PRODUCT CAMPAIGN BULLETIN

APPLICABILITY: 2019MY Ascent
 2019MY Crosstrek Hybrid (PHEV)
 2019MY Forester

SUBJECT: PCV Valve- Design Change

NUMBER: WUW-08R
NHTSA ID: 19V-856
DATE: 12/04/19
REVISED: 12/17/19

FORESTER and CROSSTREK PHEV:

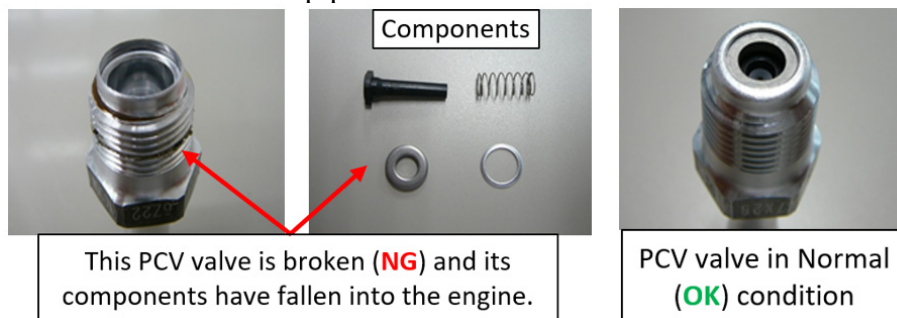
Replace the PCV Valve using p.n. **11810AA230**. Reinstall the original PCV hose.

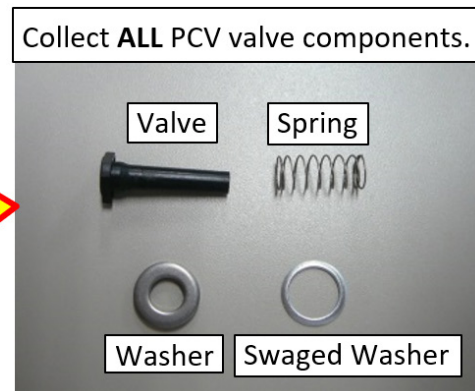
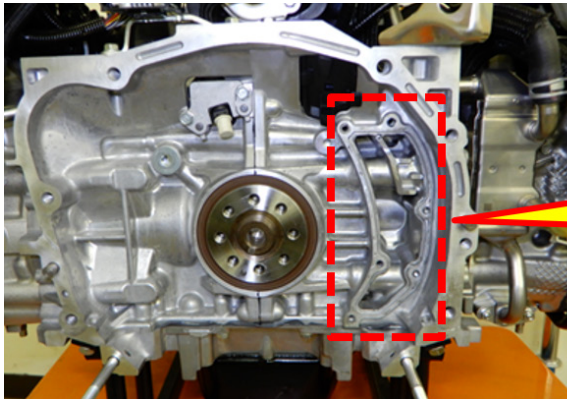
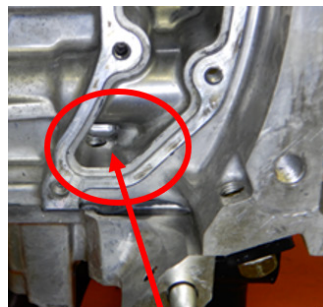
Step 2: Following the applicable Service Manual procedures, remove the oil separator cover and collect the PCV valve components (4 small parts) as shown in the photos below. If all four (4) of the PCV valve components cannot be collected after removing the oil separator cover, proceed with removing the oil pan to collect any remaining components.

Oil Pan-side Passage

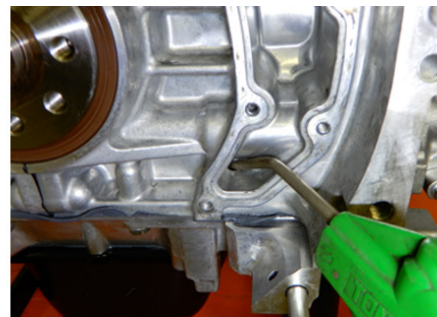
TIP: If any PCV valve components remain in the oil pan-side passage, apply compressed air to the oil pan side passage as shown below.

CAREFULLY blow air into the oil pan-side passage to collect the remaining PCV valve components.
